Global Change Notification (GCN)

GCN Number

exist part

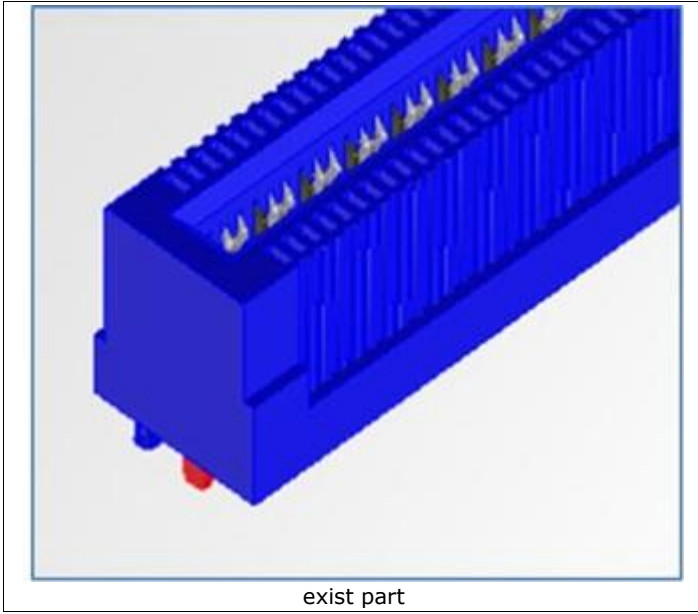
Change Description
